RE: Appeal of DRB approval of Parking Lot Lighting at 478 Cambridge Drive

This office represents appellant Kalia Rork in the appeal of the Design Review Board's approval of proposed lighting in the parking lot at 478 Cambridge Road.

RE: 478 Cambridge Drive Parking Lot Lighting

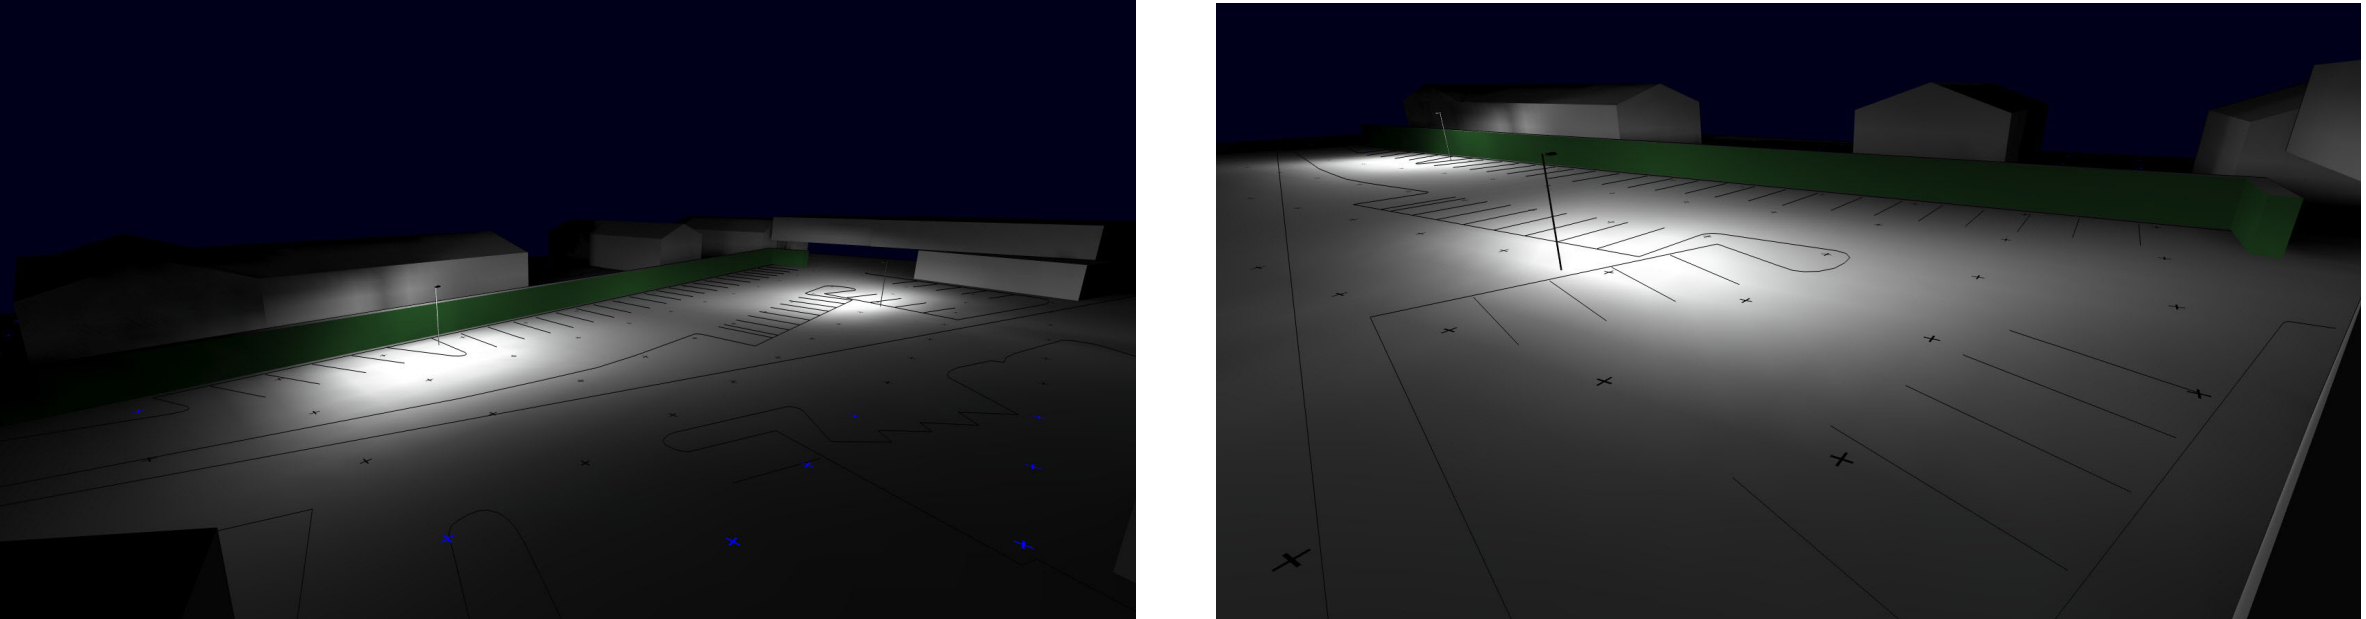
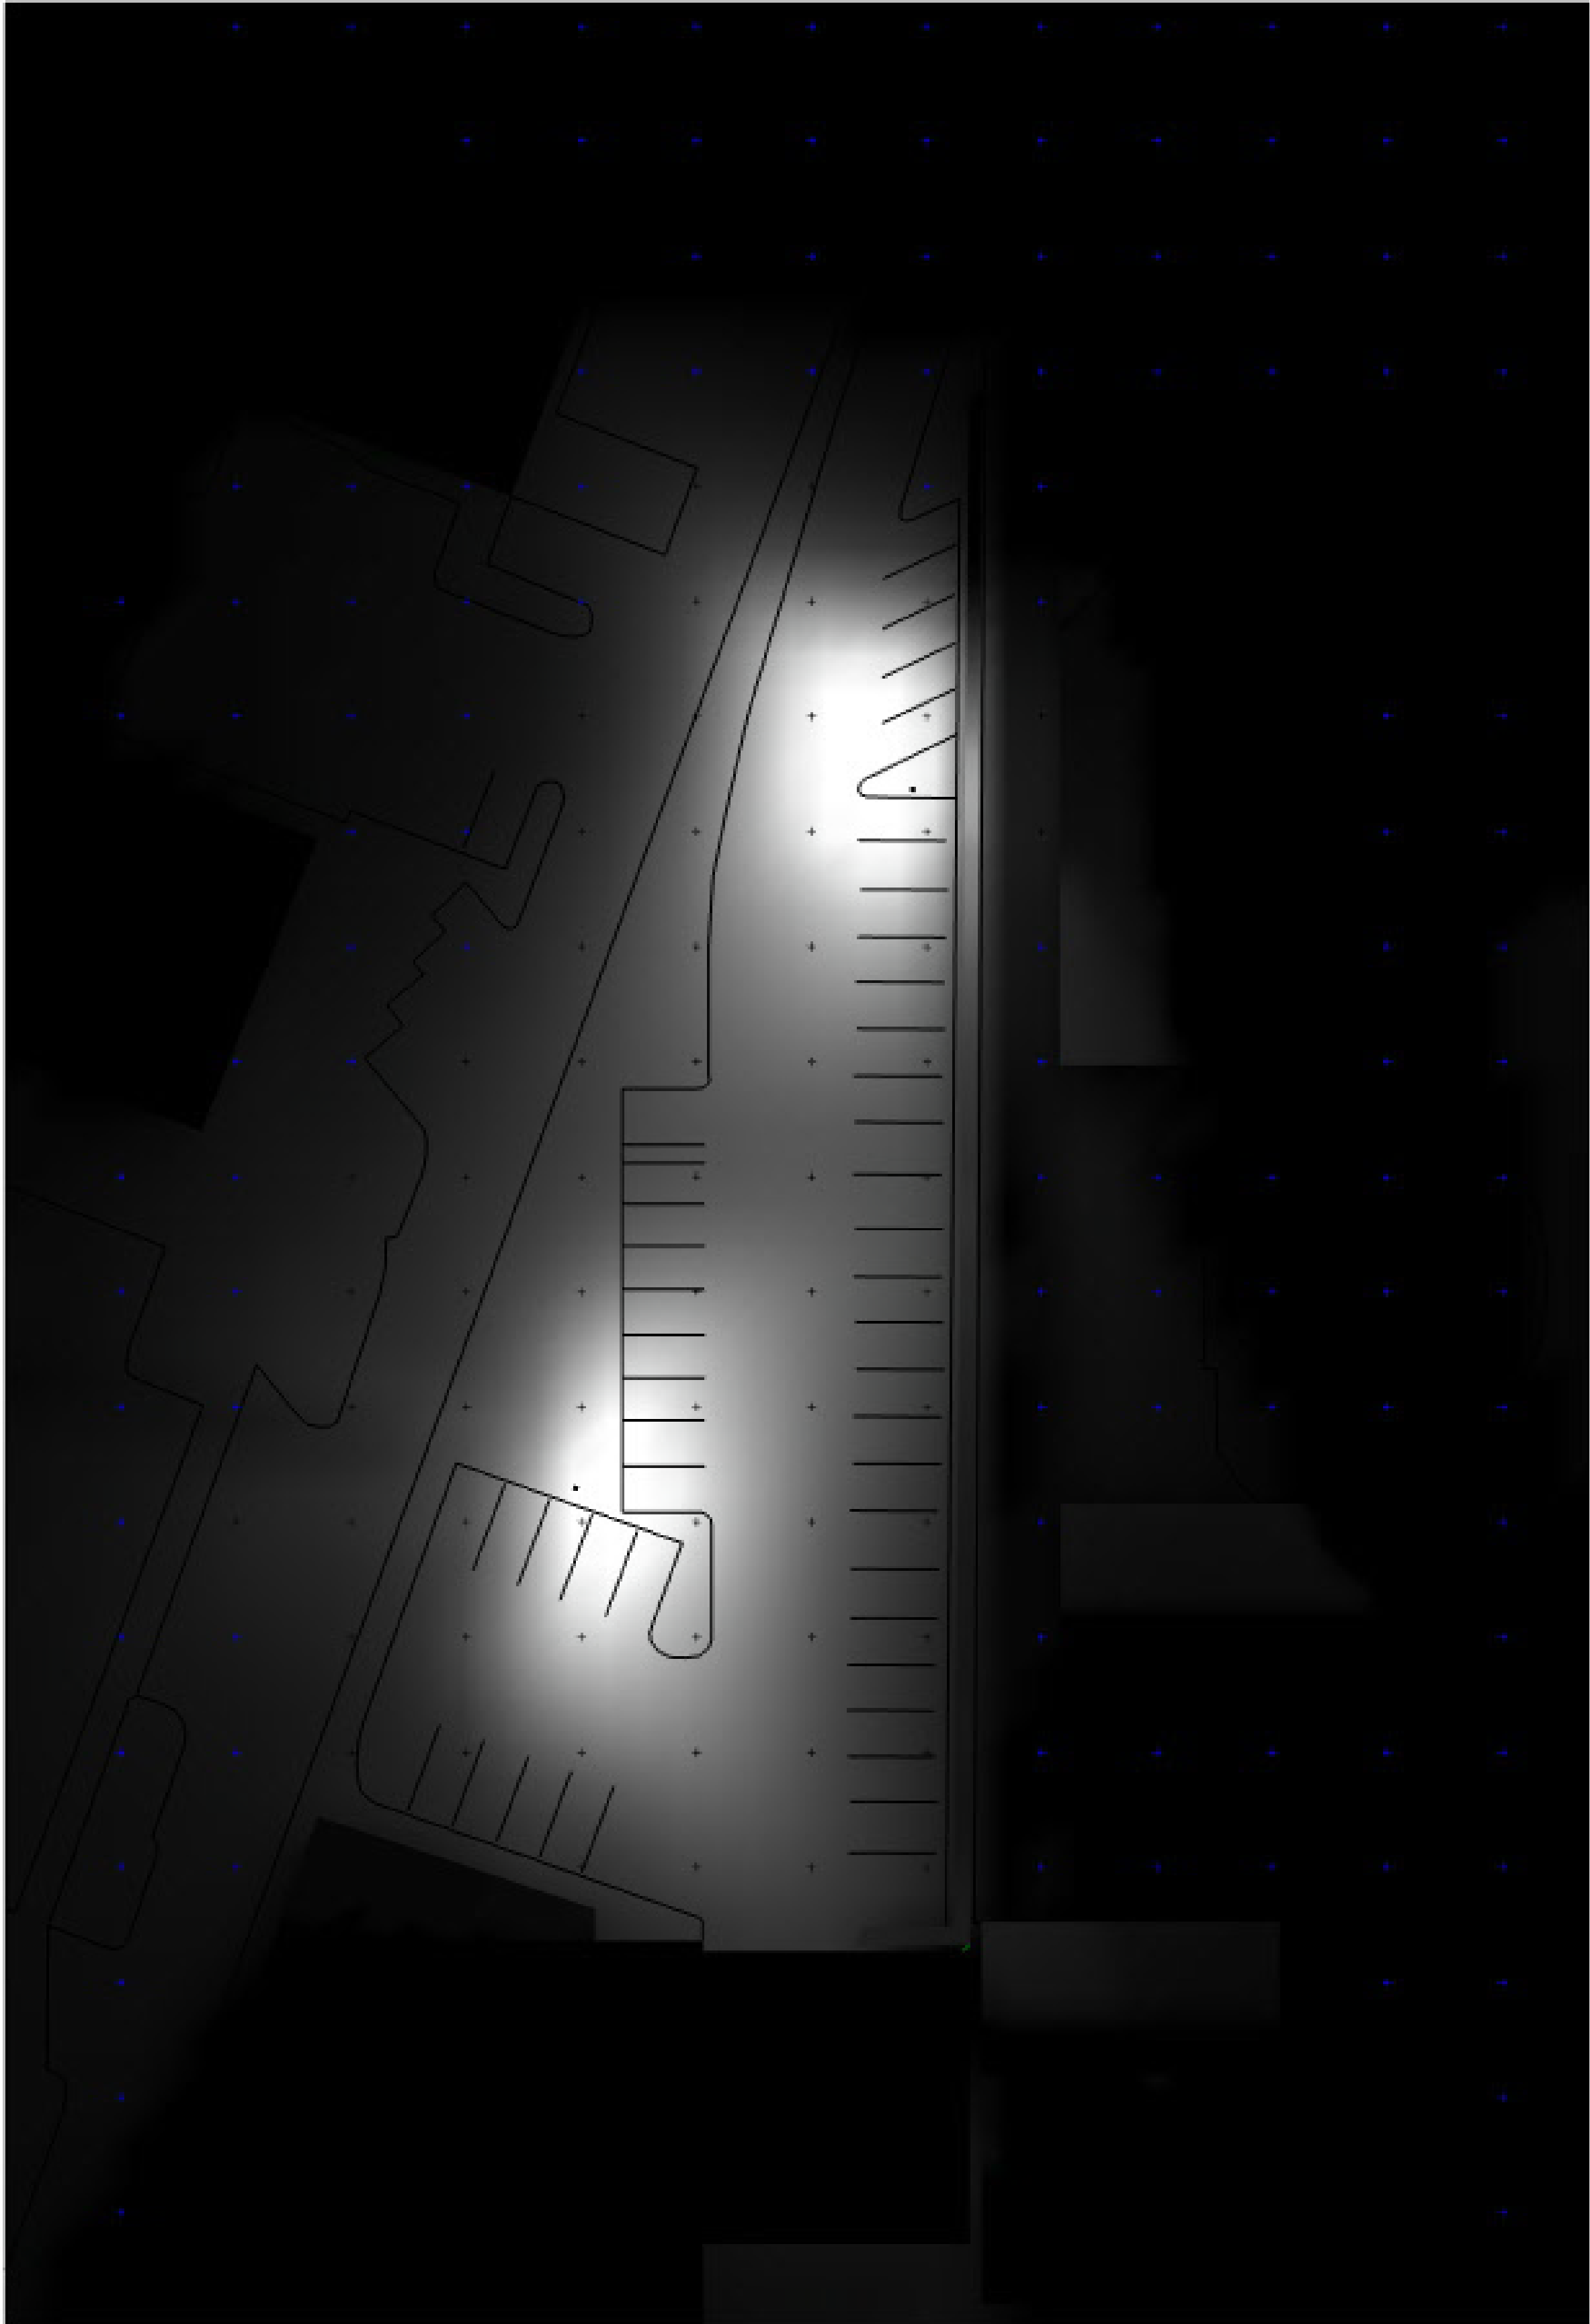
But 200 watts is too much for this application, especially with 14' poles. Exhibit B is the manufacturer's fixture recommendations and lighting study for a comparable parking lot. Westgate, the manufacturer, recommended using smaller fixtures, set at not more than 150 watts, for a comparable parking lot. See Exhibit B, Lighting Study from Westgate.

Further, the manufacturer of the lighting equipment has concluded the fixtures are more bright and powerful than necessary for the proposed application.

Exhibit C

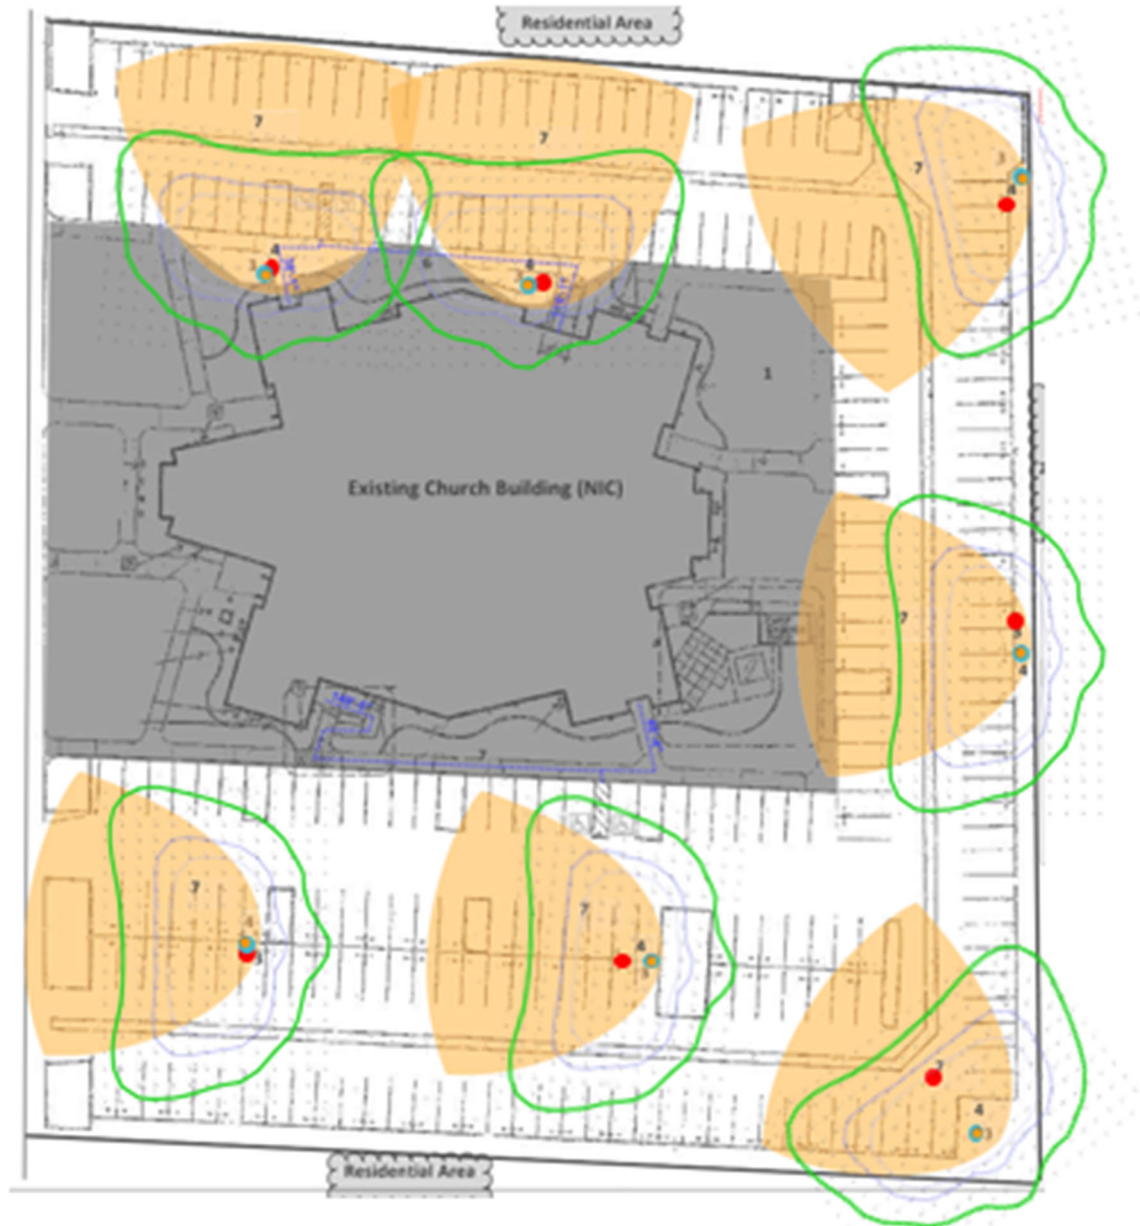
The Applicant's Site Plans (Demo Site Plan A001a and Proposed Lighting Site Plan A002, at PC packet pages 60 and 62) show the location of the existing light poles and fixtures while the Photometric Plan (A003, packet page 63) locates these poles and fixtures in different locations. See Exhibit C, which overlays the site plan and photometric plan. The inaccurate Photometric

Plan has most of the project's light poles in the wrong location, with the largest error associated with the pole closest to Appellant Rork. Since the project description calls for replacing the existing poles in the same location with no change in wiring, the photometric grid must be based on an accurate location of the existing poles. The Lighting Plan's Photometric Plan relies on these wrong locations to calculate the project's illumination, misstating the impact and rendering the Lighting Plan wholly defective.

This error hides the project's impact on surrounding and adjoining properties. If the Photometric Plan had used the Site Plan's locations, it would have shown extensive light trespass into Ms. Rork's backyard. See Exhibit C.

In this case, the site map and lighting plan are inconsistent with each other, and the actual location of the pole closest to appellant Rork will have much more severe impacts than shown in the applicant's photometric grid and study. The applicant's general contractor has no stated expertise in photometric modelling or even regulatory processes.

1. Eliminate the three poles on the east side entirely (since they are not shown accurately on the project plans and photometric study, will introduce lighting into adjacent residential areas, and light areas that are not needed for parking to serve the building's nighttime activities)

**Willow Creek
Apartments near
City Hall. Reading
at base of pole
light on left
measures 0.8 fc.**

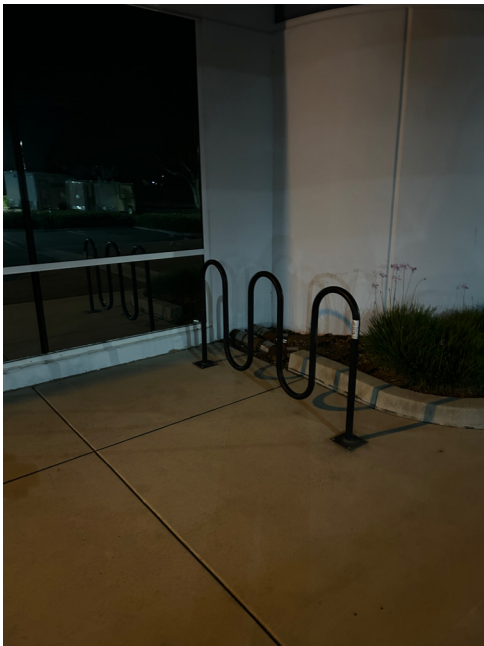
Near City Hall are a group of apartment buildings called Willow Creek. If you go over there at night, near the entrance is a leasing office and community building. This area appears to be very well lit as well. There is a street light pole near the entrance, which lights up the entire area. Directly under this light at its brightest point, the fc are 0.8. The handicap parking spots right in front measure at less than 0.1, and they are also well lit.

**Reading at
handicap
parking out front
measures 0 fc.**
